## **Appendix 1**

# **Replacement Pages of Air Ventilation Assessment**

Project  
PROPOSED COMPREHENSIVE DEVELOPMENT AT  
KAI TAK AREA 2A SITE 2, KAI TAK DEVELOPMENT AREA, KOWLOON

Drawing Title BUILDING SETBACK DIAGRAM			
Drawing No. SK-01	Revision No. A	Scale 1:400	Date 29 JUL 2024

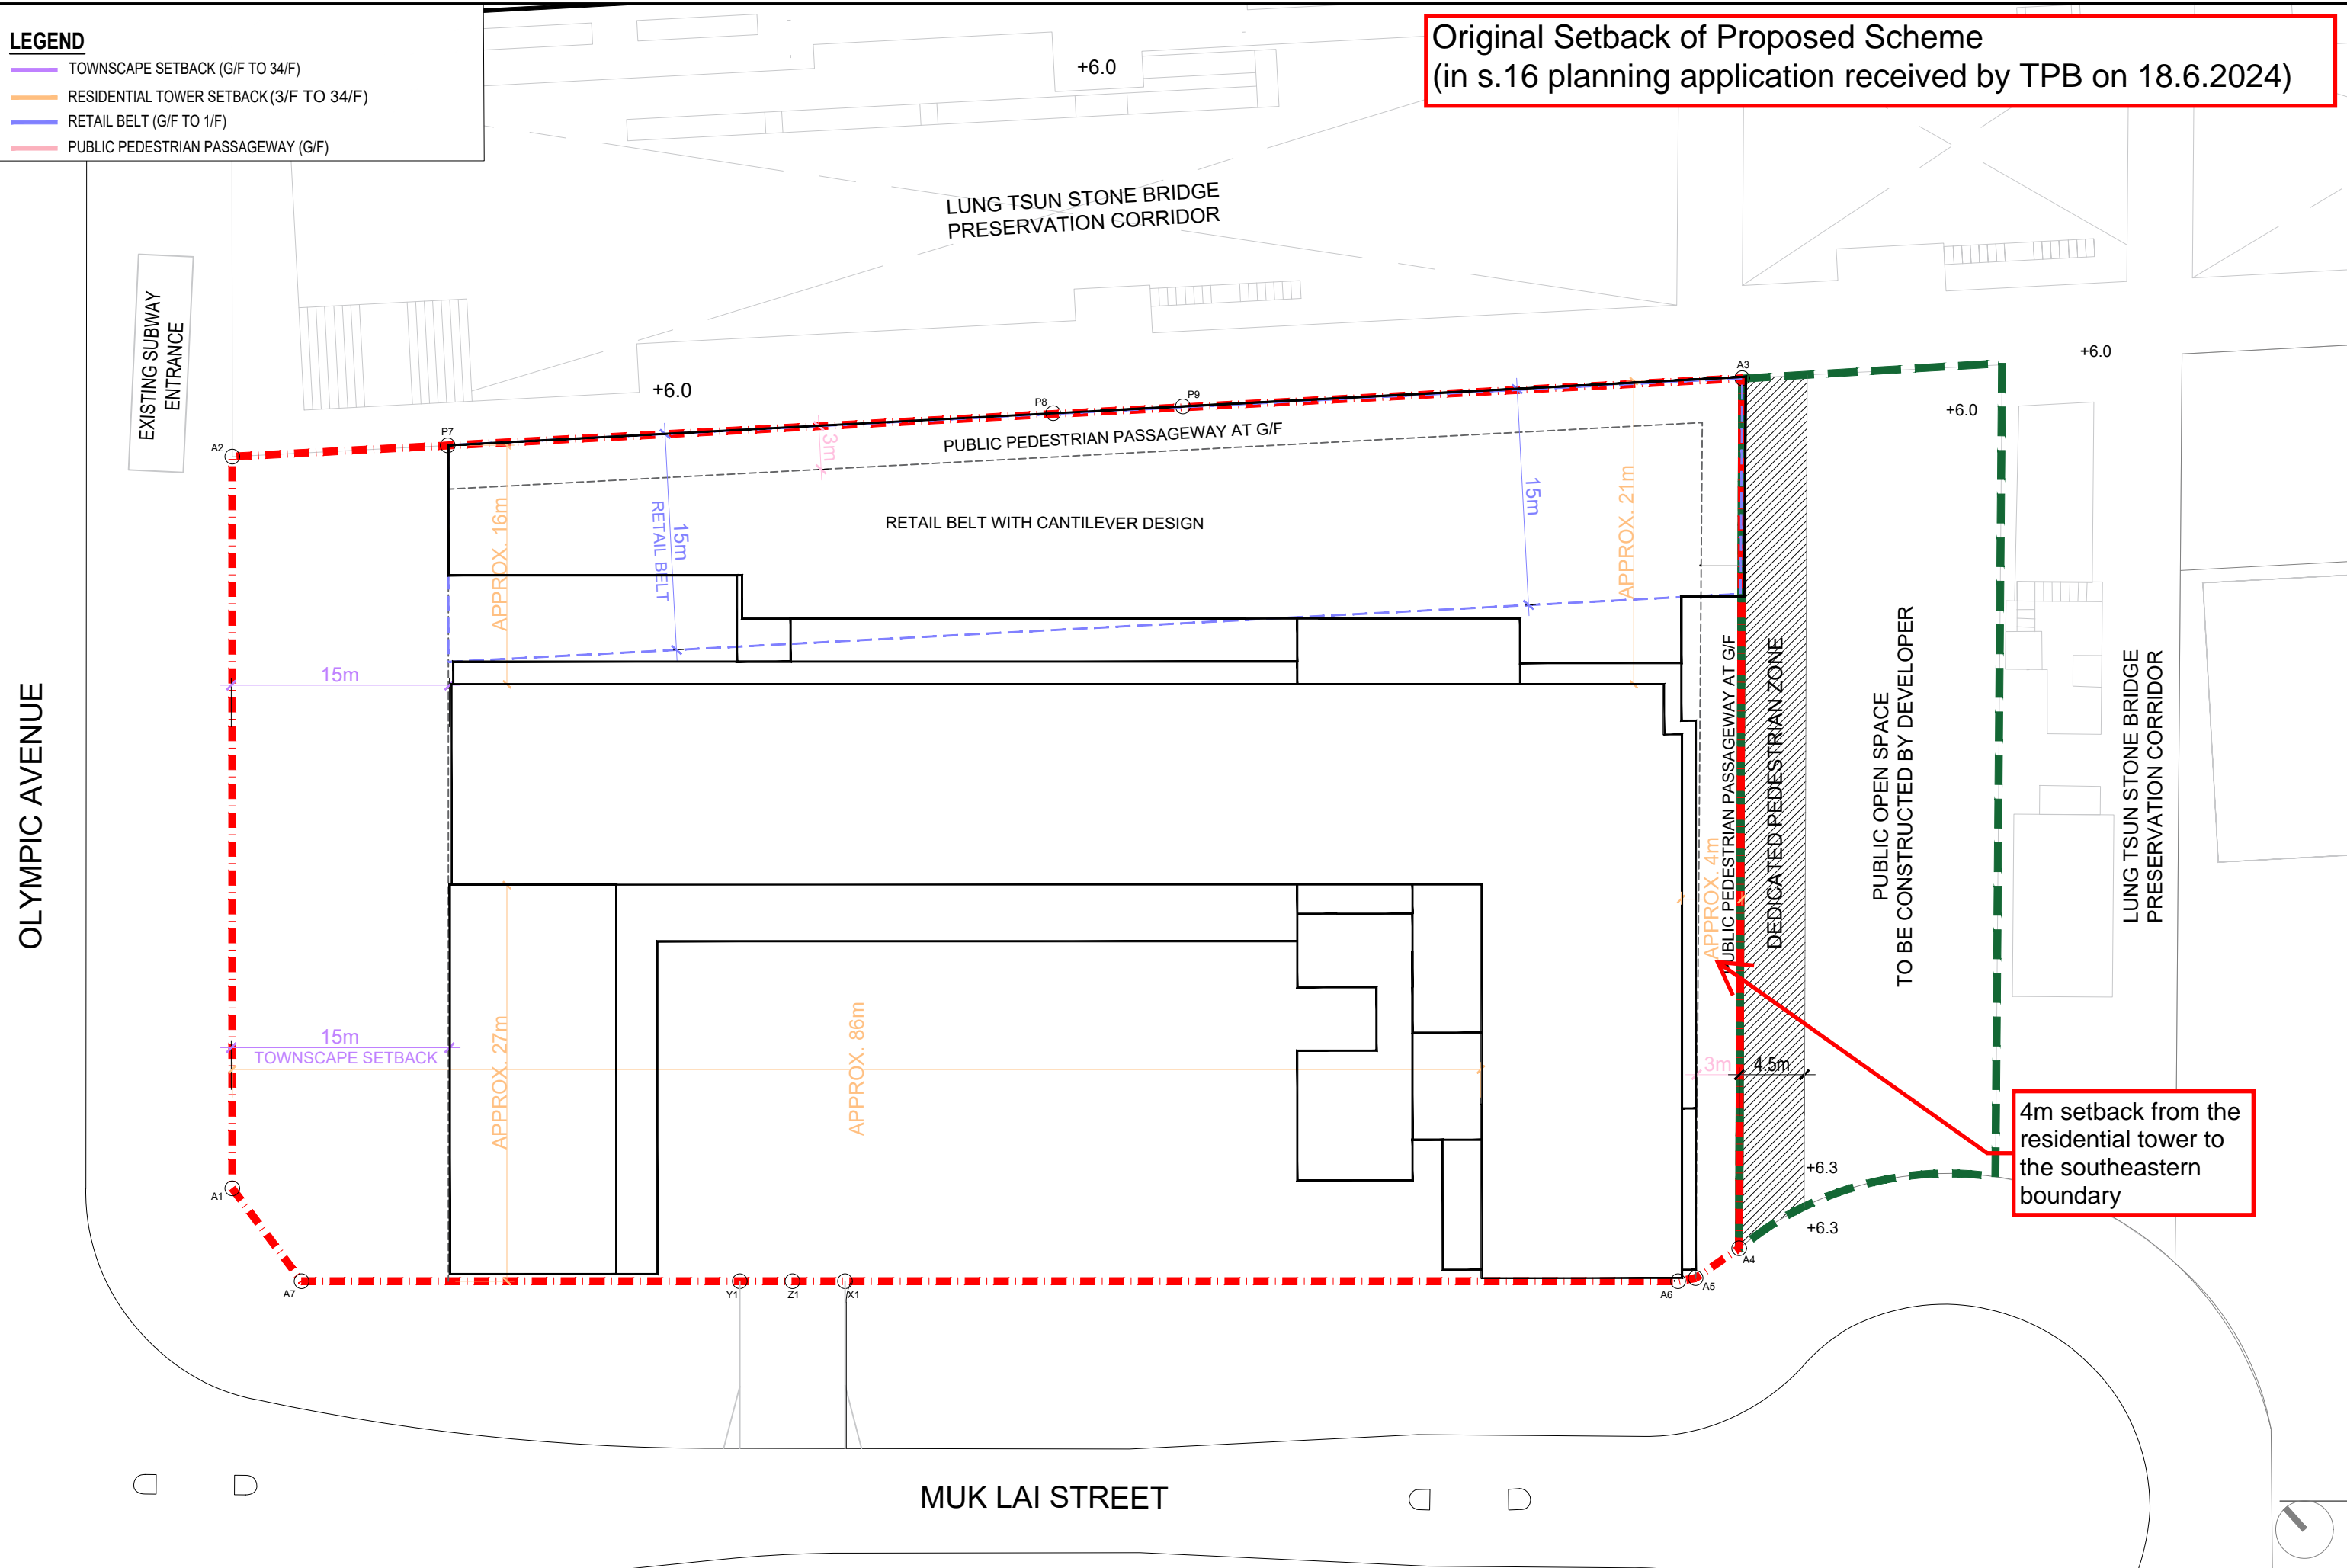
Original Setback of Proposed Scheme  
(in s.16 planning application received by TPB on 18.6.2024)

4m setback from the residential tower to the southeastern boundary

Latest Setback of Proposed Scheme  
(in FI(1) received by TPB on 7.8.2024)

minimum 3m setback from the residential tower to the southeastern boundary
